## VARIANCE REQUEST

1. Date : 6/30/94  
2. Review Engineer : Fred Evans  
3. Date Received : 11/12/92  
4. Facility Name : Cocklin's RV Campsite  
5. County Number : 58  
6. Program Area : CP  
7. Facility Type : C05  
8. Subject Area : 308  
9. Rule Reference : 64.2(3)C  
10. Design Std. Ref. : 14.2.3C  
11. Consulting Engr. : MMS Consultants  
12. Variance Rule : 64.2(9)  
13. Decision: Approved  
Date: 1/11/94  
14. Appeal:  
Date:

Re: Subsurface Sand Filter  
Cocklin's RV Campsite, Columbus Junction, Iowa

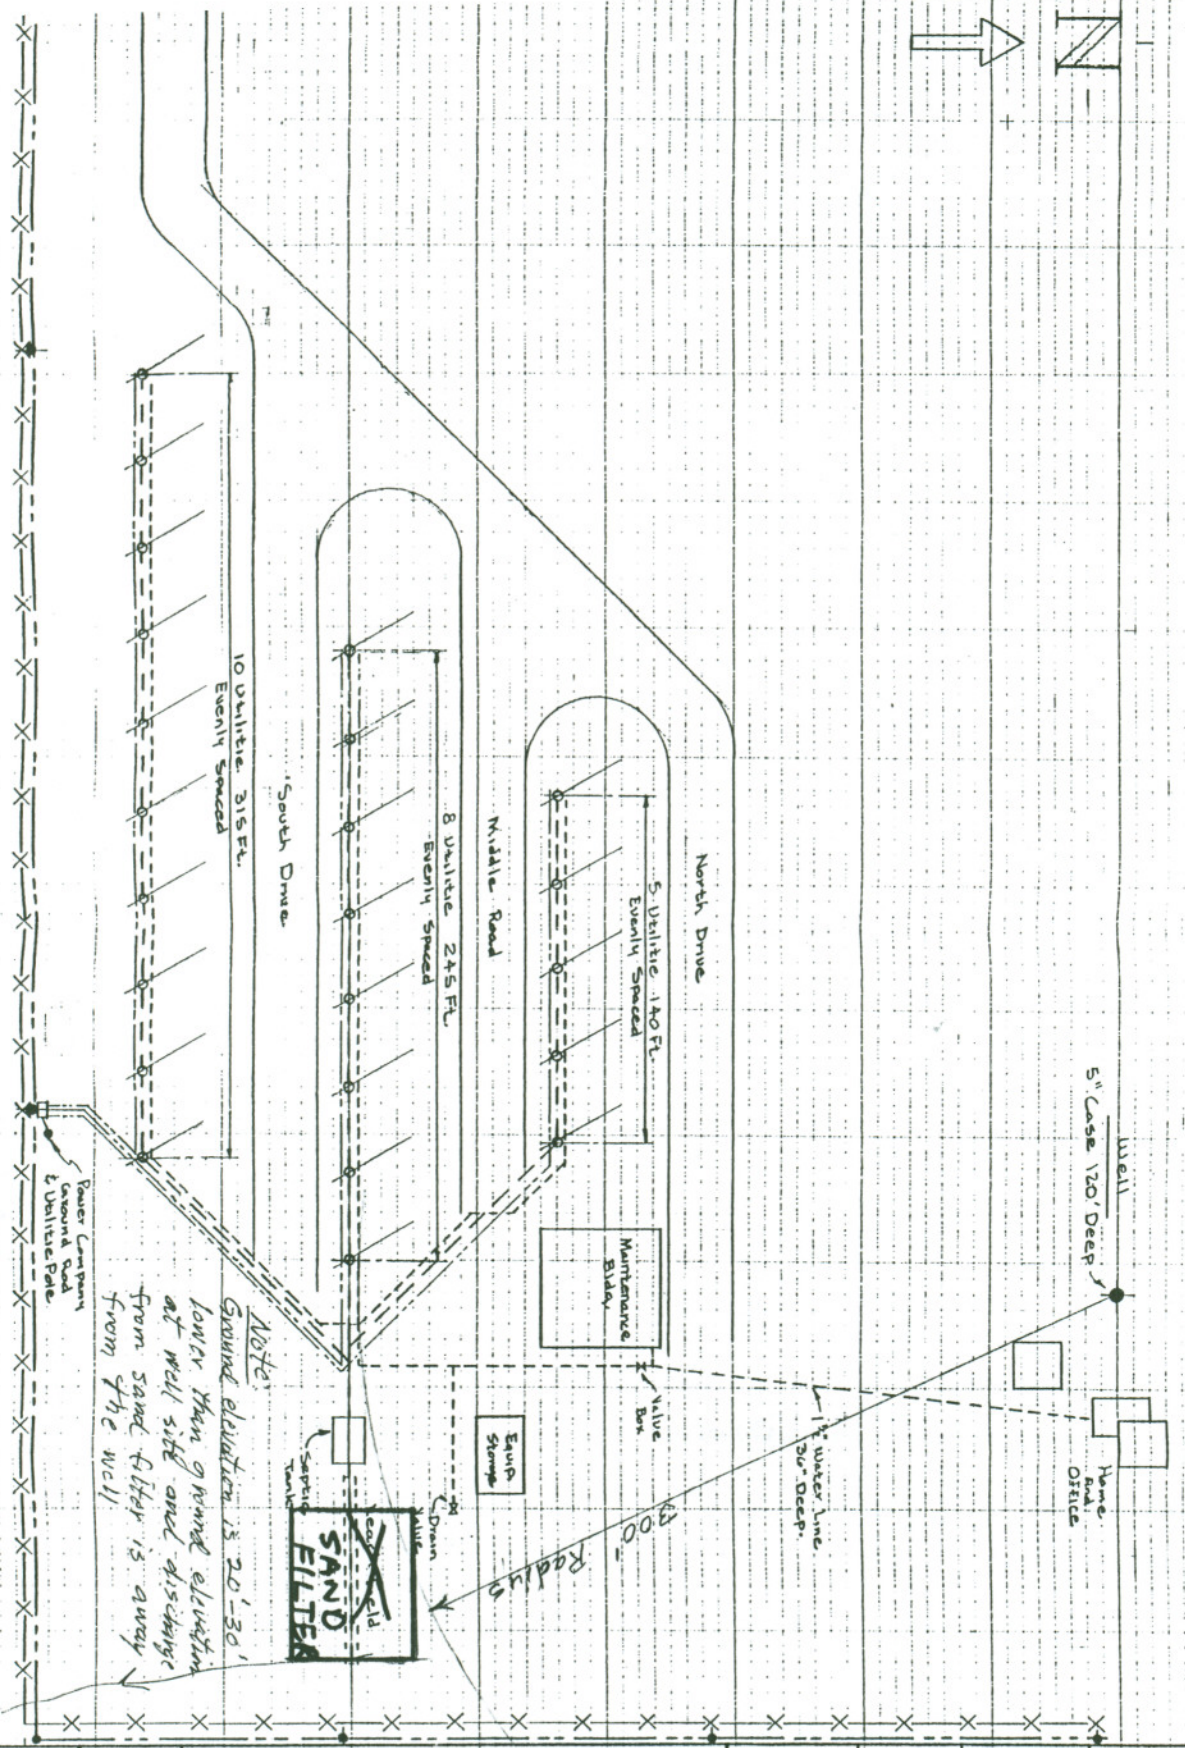
In accordance with our previous telephone conversations concerning the above referenced project, we are hereby requesting a variance from I.A.C., Chapter 64.2.3 which requires a 400 foot separation distance from the proposed sand filter to Mr. Jerry Cocklin's existing deep well.

Since Mr. Cocklin's well is over 100 feet deep, and in accordance with D.L. Gordon's December 11, 1991 letter from Iowa Geological Survey which indicates that groundwater degradation will not occur with the proposed sand filter, we ask for approval of the sand filter and well site locations which are approximately 300 feet apart.

The maximum pumping rate of 15 gpm in the well only produces a 15-foot drawdown and a maximum daily water usage is forecasted to be 4,000 gpd. The maximum daily wastewater flow is forecasted to be 2,300 gpd which is equivalent to approximately six (6) doses per day in the proposed sand filter. The general topography of the sand filter site is sloping away from the well site and the ground elevation at the sand filter site is approximately 20-30 feet lower than the well site. Any surface or subsurface sand filter effluent will flow towards Turkey Run Creek and away from the well.

1. The required modifications to the existing private well to comply with our design standards for public wells have been completed - see 3/30/94 letter from MMS Consultants.
2. Donnian Gordon of The Geological Survey Bureau advises that the thick till in the area should protect water supply sources from potential percolating wastewater - see letter of 12/11/91.
3. The separation distances from wells in Table "A" from IAC Chapter 43 requires only a minimum separation distance of 200 feet between public deep wells and soil absorption fields (also subsurface sand filters - copy of Table A is attached. IAC Chapter 69 also requires a minimum distance of 200 feet between public wells and subsurface disposal systems.
